NUREG/CR-4142
UCID-20330

A Review of the Millstone 3 Probabilistic Safety Study

A. A. Garcia, D. L. Bernreuter, T. E. McKone, P. D. Smith (LLNL), P. J. Amico (Applied Risk Technology Corporation), J. W. Reed, M. W. McCann, Jr. (Jack R. Benjamin & Associates, Inc.), P. R. Davis and G. Apostolakis (Consultants)

Prepared for
U.S. Nuclear Regulatory Commission

Fig. 3.2-1. Large LOCA event tree.

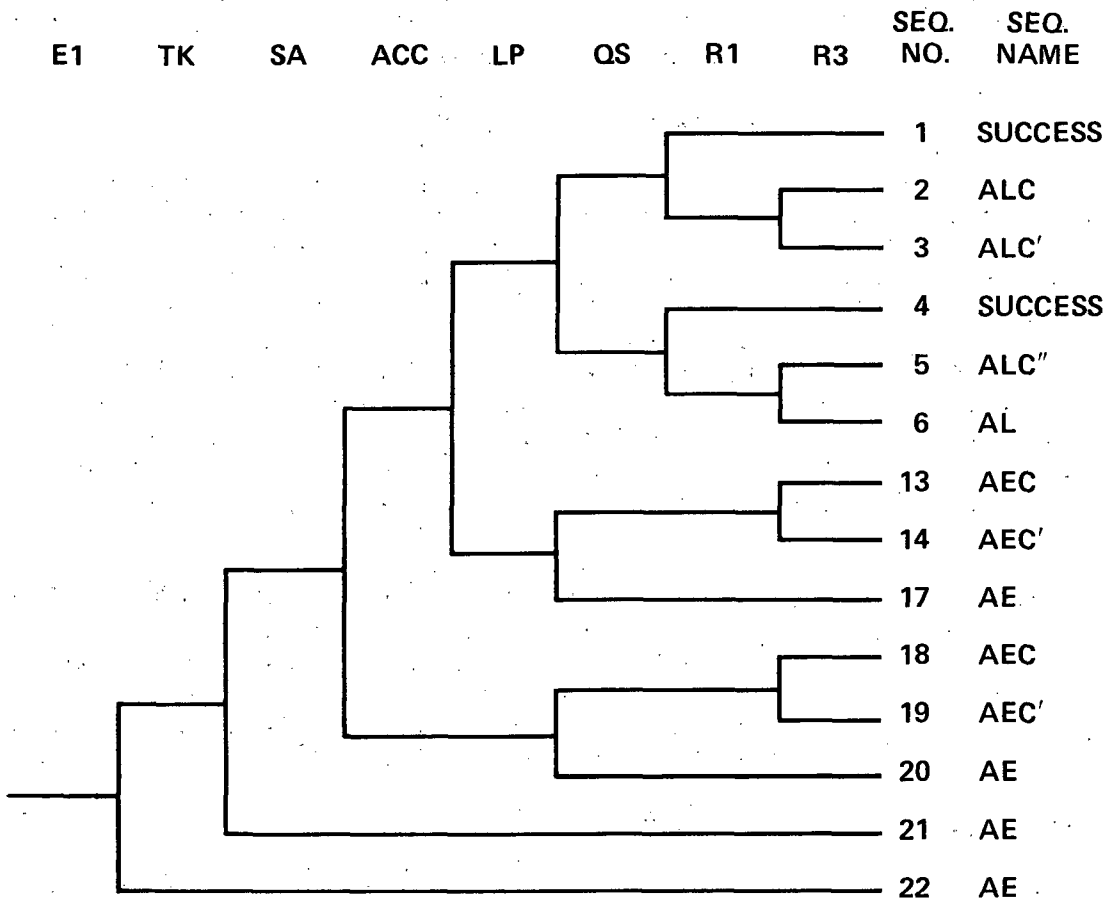
amounts of water through the suction lines. At this point, pump cavitation could occur and the pump could trip on low suction pressure or overspeed. If pump trips are not provided, as is the case at Millstone, the pumps could be destroyed. In either case, the pumps would not be able to provide coolant to the RCS. There is no reason to believe that the Millstone pumps are immune to this phenomenon, and the assumption that HPI could supply injection during large LOCAs is not justified. The event tree shown in Fig. 3.2-1 has been modified to reflect this judgment.

Fig. 3.2-5 Steam generator tube rupture event tree.

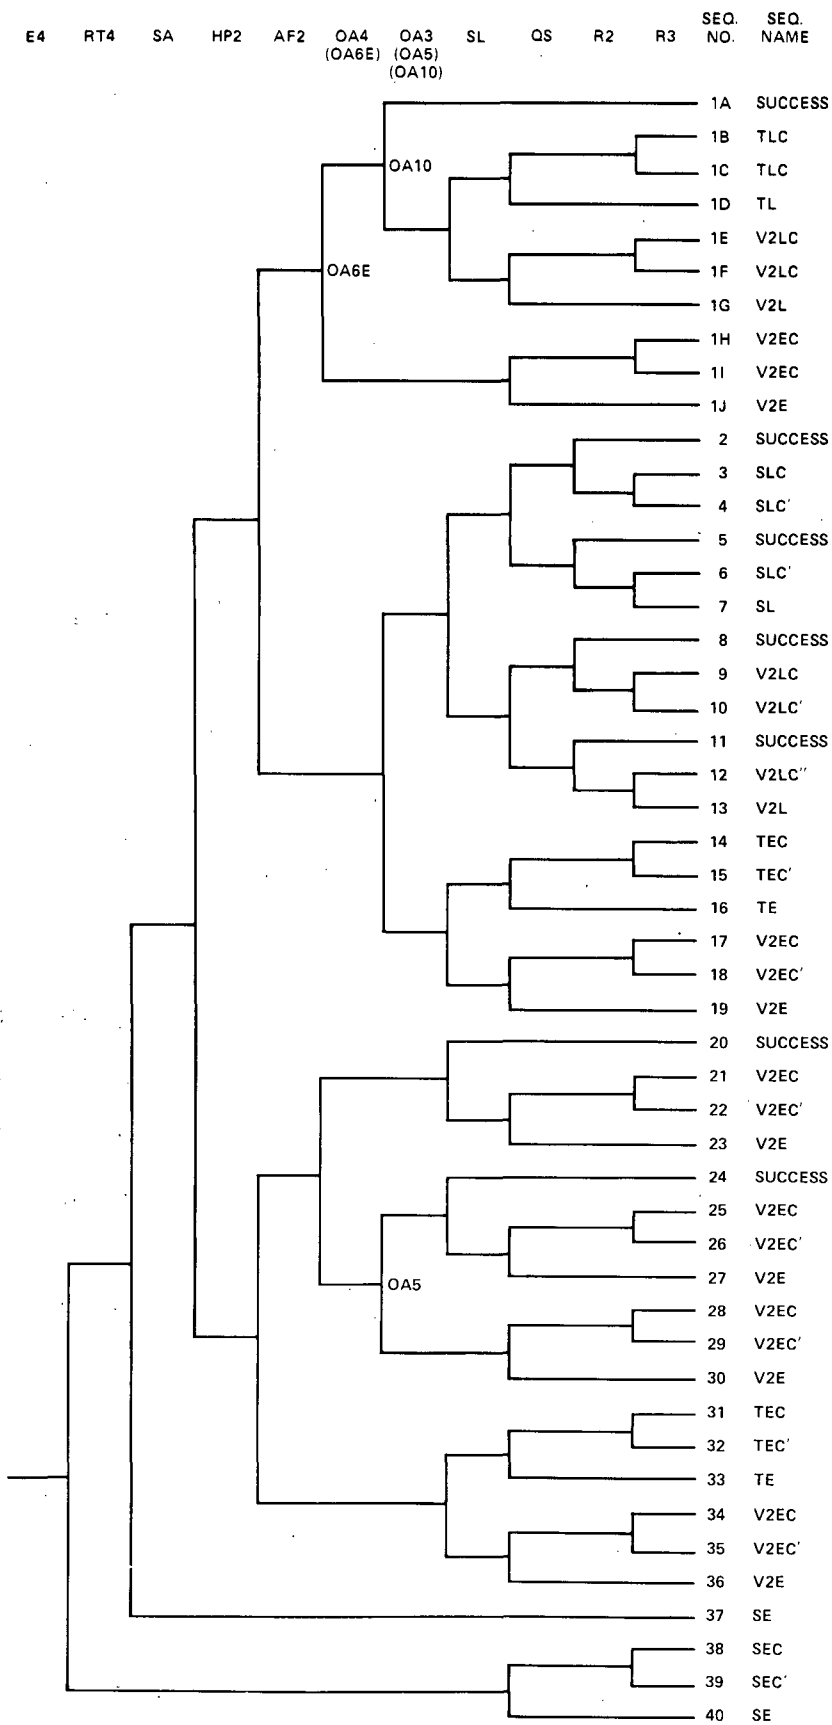
The SGTR tree shown in Fig. 3.2-5 has been modified to include this action.

Fig. 3.2-10 Spurious safety injection event tree.

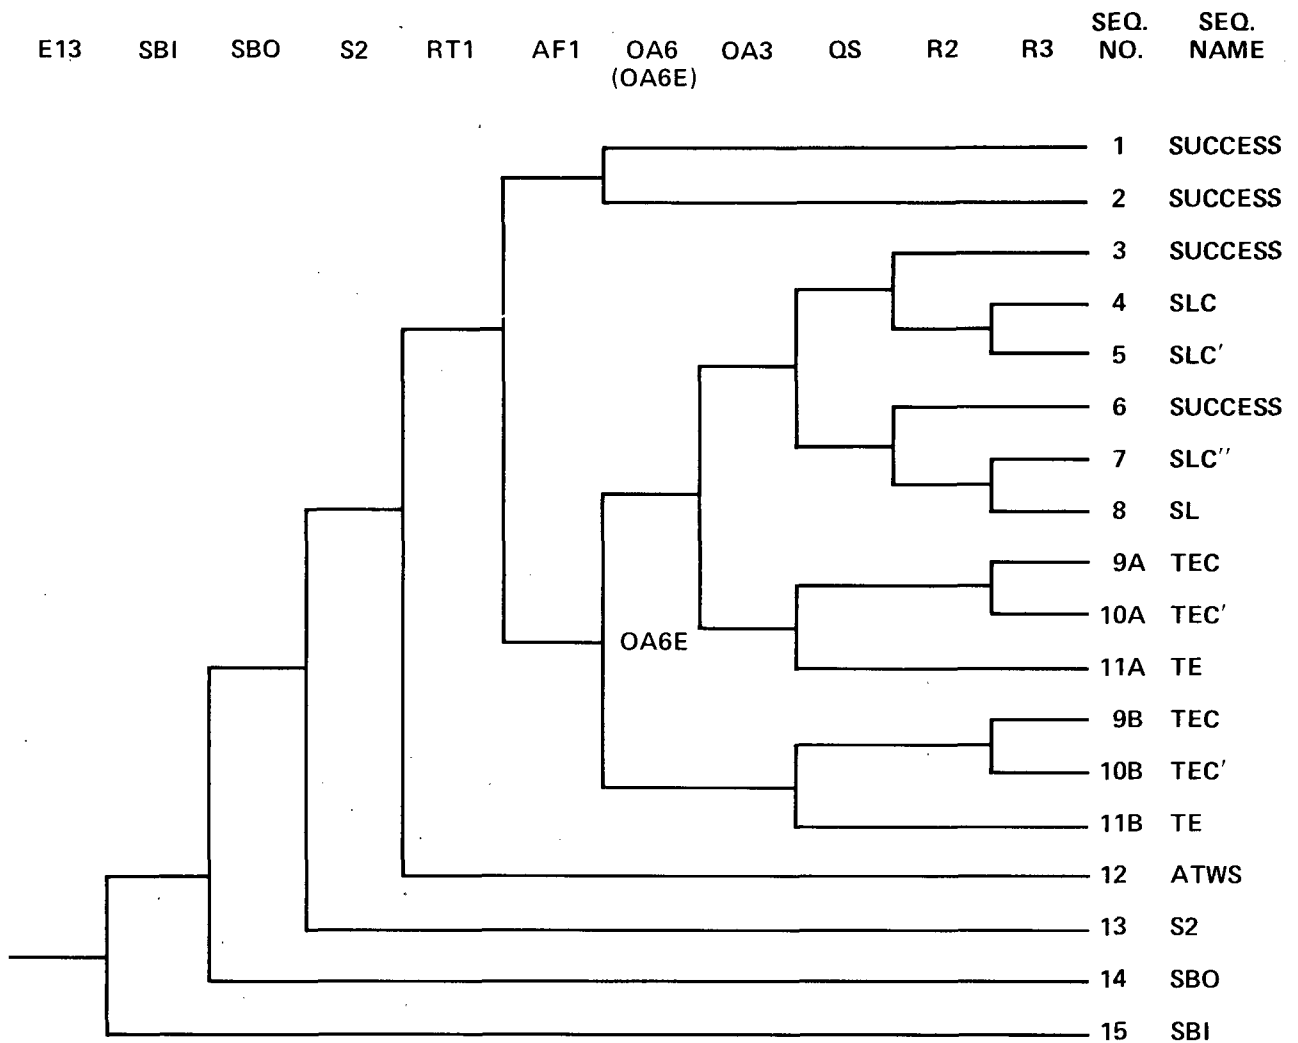
The use of operator action OA-7, primary bleed and feed, is incorrect on this tree. While bleed and feed cooling is valid for this event, OA-7 includes the unavailability of HPI in its unavailability value. The initiating event itself implies that HPI is already operating. Further, the other events on the tree, such as OA-6, assume that HPI is already operating. Thus, the proper event to use on the tree would be operator action OA-3, primary bleed. This would serve to establish bleed and feed cooling. The modified event tree is shown in Fig. 3.2-10.

Fig. 3.4.16-2 Fault tree model of loss of vital DC bus.

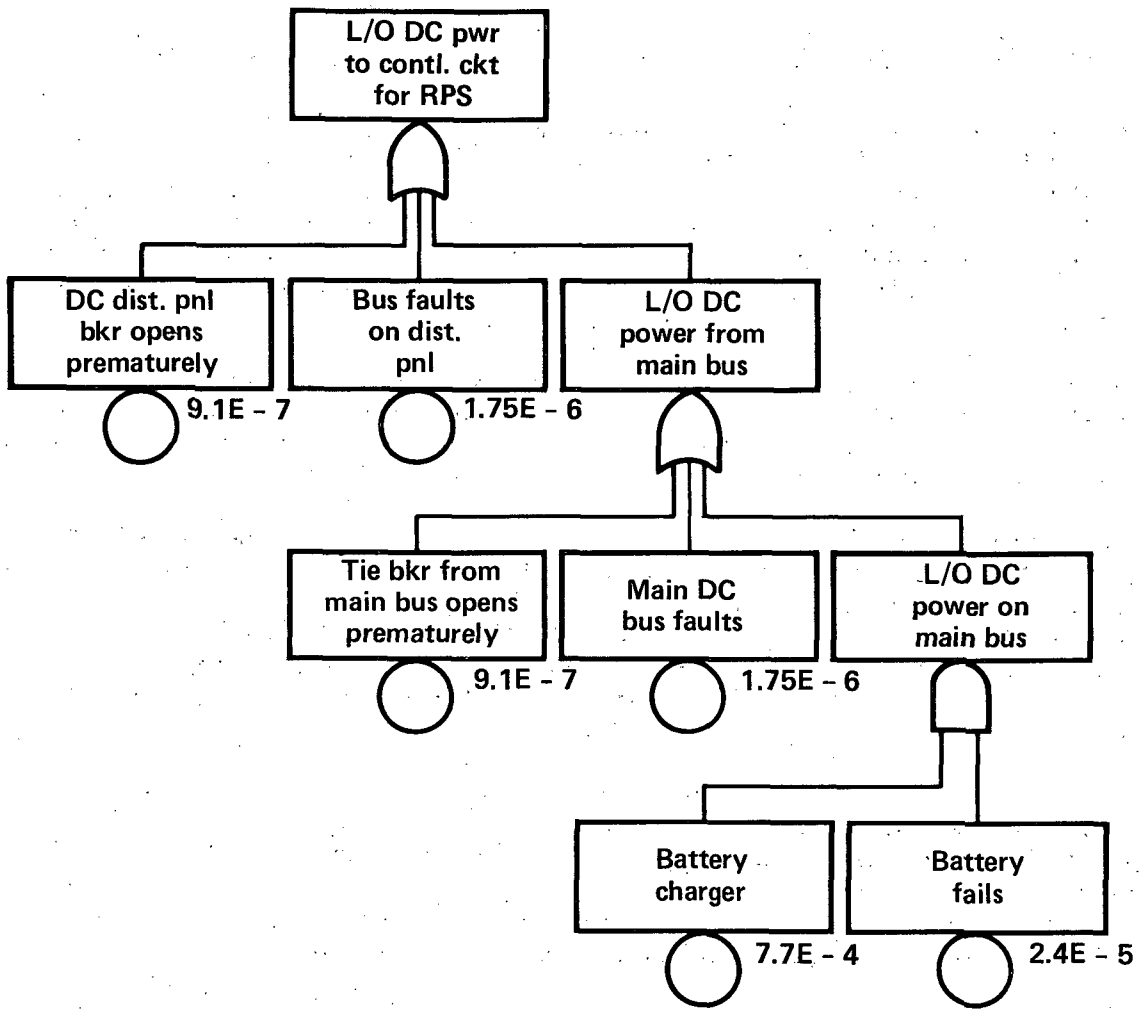
One concern involves the failure of the fault tree to model the unavailability on demand, given that there has been a loss of offsite power. The fault tree (Fig. 3.4.16-2) models the availability of DC power given that AC power is available in the vital AC. The structure of the tree does not allow the determination of DC unavailability given loss of offsite power. During the first few seconds of this event, the portion of the vital DC system which includes the batteries and the components that transmit power from the DC bus to the vital AC bus and the EGLS is a crucial subsystem whose failure could rapidly lead to potentially serious damage states (see Section 3.4.4).

Another issue concerns two questionable assumptions used in the determination of the failure rate for both DC channels. One is that there is no potential for common-cause failures in the DC system. The second involves allowing credit for the recovery of a single channel once it has failed. These assumptions result in much lower failure rates than would otherwise have been calculated. Although these issues could have required a requantification of the entire system, a comparison of the PSS value with the value in the ANO-1 IREP (Ref. 3.4-4) found it to be consistent, so that no requantification was necessary.

Fig. 3.9-2 MP 3 simplified RHR system from S&W drawing no. 12179-EM-112A-1 (4/14/82).

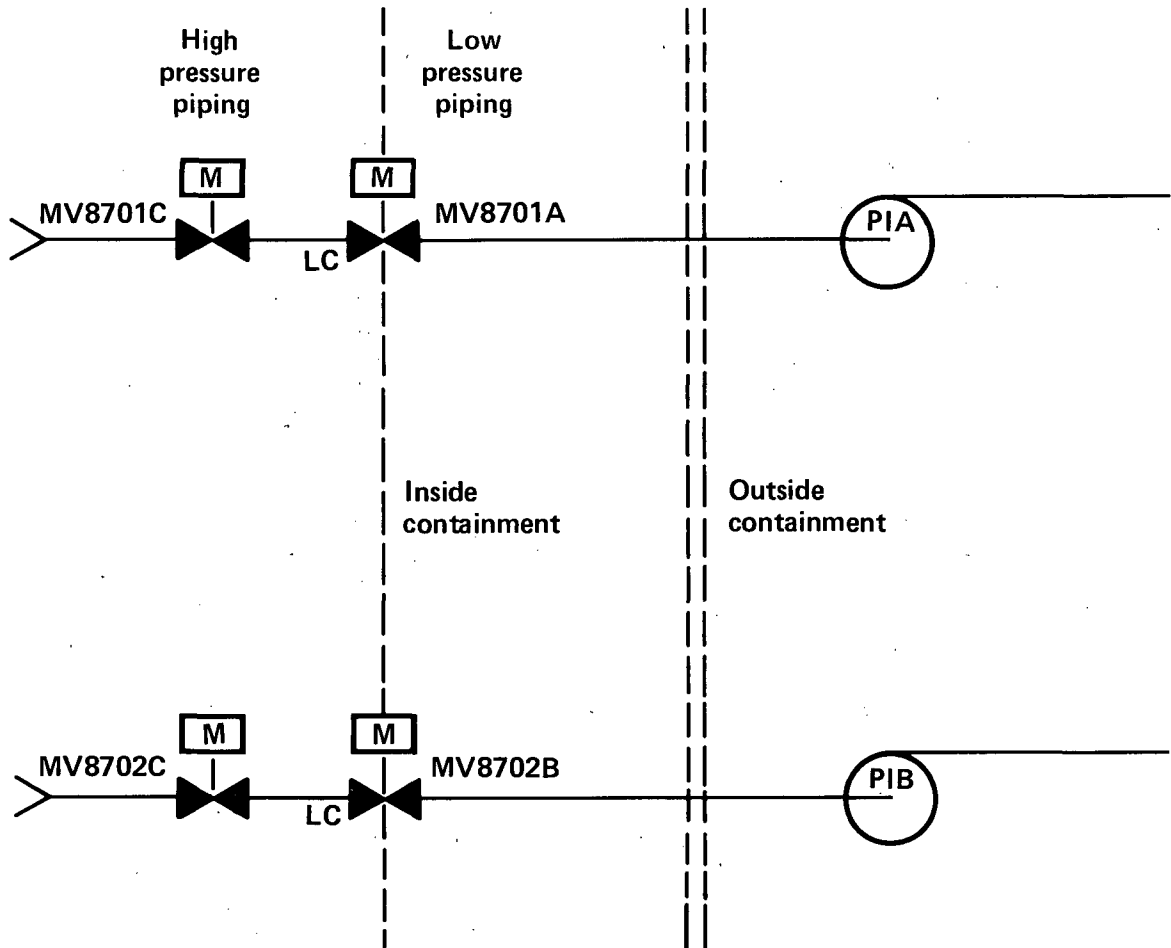
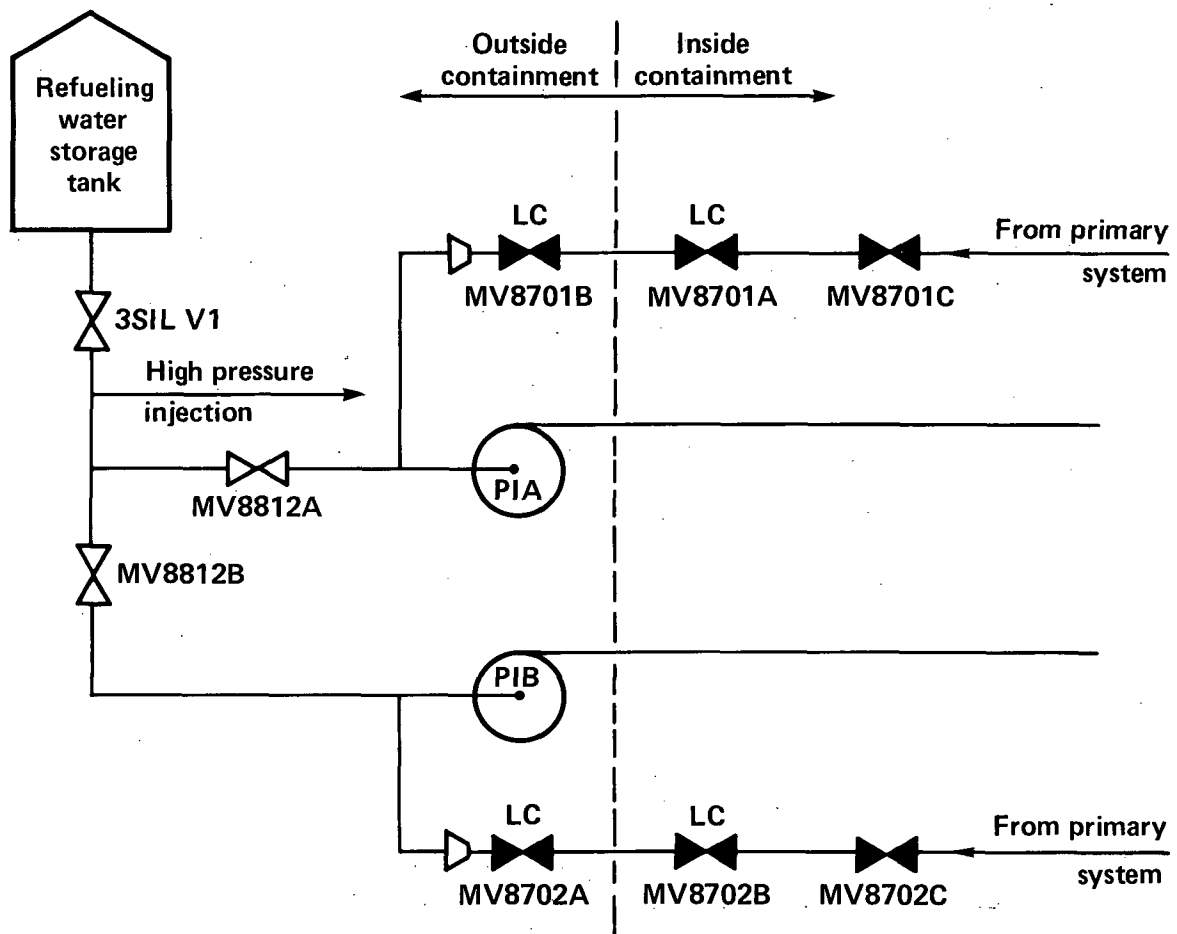
Figure 3.9-2, which is based on P&ID drawing S&W #12179-EM-112A-1, indicates that a third valve (MV8702A and B) exists in both RHR suction lines. Based on other plant designs, it seems likely that the transition from high to low pressure pipe would occur at the location of these valves rather than inside the containment. If this is the case, the probability of the V-sequence accident would be reduced dramatically since a third valve, normally locked closed, would have to fail. (The S&W drawing does not indicate the design pressure transition point.) If low pressure pipe is located between the inside and outside valves (as implied by the PSS assessment), then there is a possibility of a rupture outside containment. However, depending on relative pipe segment lengths inside and outside the containment, the probability of an outside rupture would be reduced over the PSS value.

- b. The PSS description of the progression of the V-sequence accident is very sketchy, and some of the results seem unusual. If the accident were to occur, it appears that the pipe would rupture in the RHR pump cubicle. Following rupture, a high energy blowdown process would ensue. This would likely cause pipe whipping and the generation of high velocity debris in the pump cubicle. It seems

Fig. 3.9-3 Example event tree for V-sequence

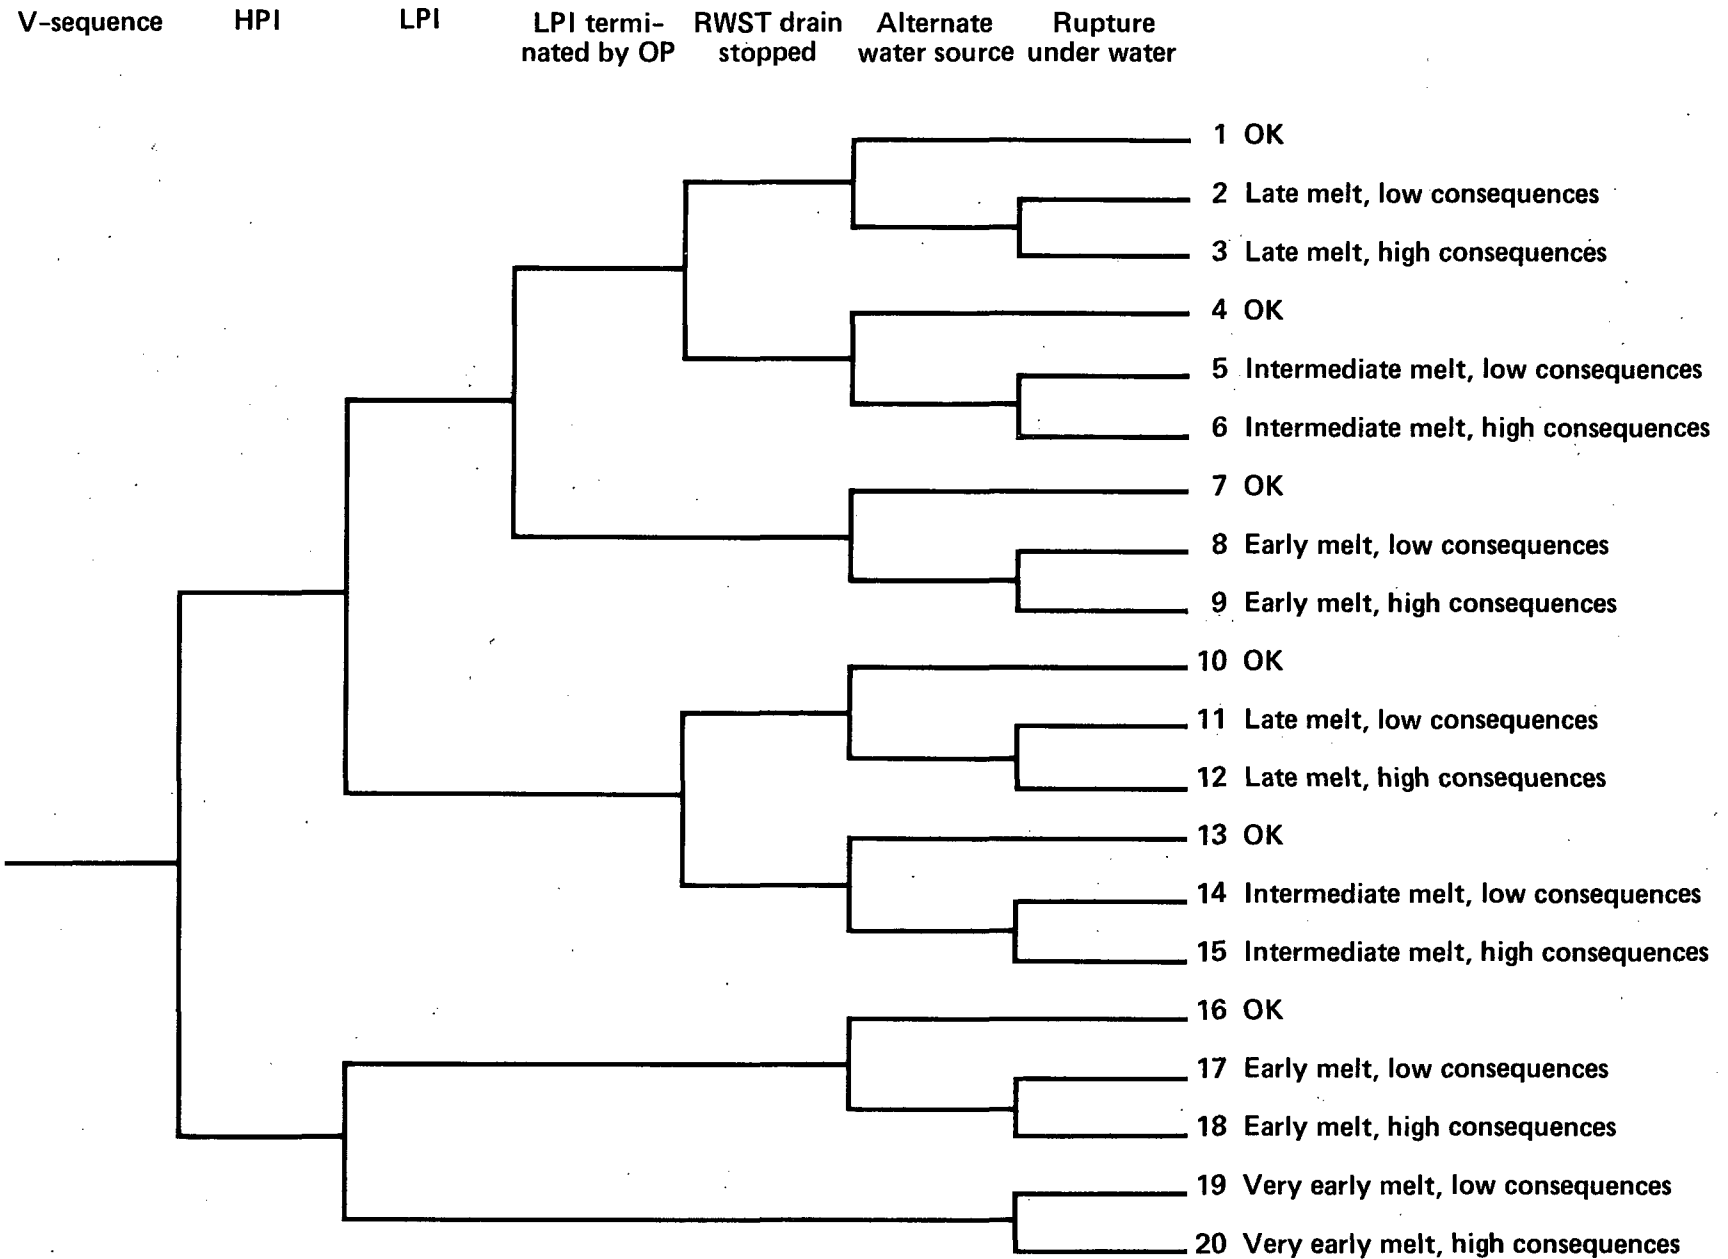
The preceding discussion suggests that the V-sequence accident is a complex event with many possible outcomes depending on assumptions made and operator actions taken. Figure 3.9-3 qualitatively depicts these alternatives in event tree format. As indicated by the figure, some 20 different outcomes appear feasible. Of these 20, some 17 would appear to result in lower offsite consequences

(and therefore lower risk) than assumed in the PSS due to either sustained core cooling, delayed melt, or removal of radionuclides from a submerged rupture. The only scenario apparently considered in the PSS is No. 9 in Fig. 3.9-3. Quantification of the event tree in Fig. 3.9-3 would require additional effort and detailed knowledge of plant design features.
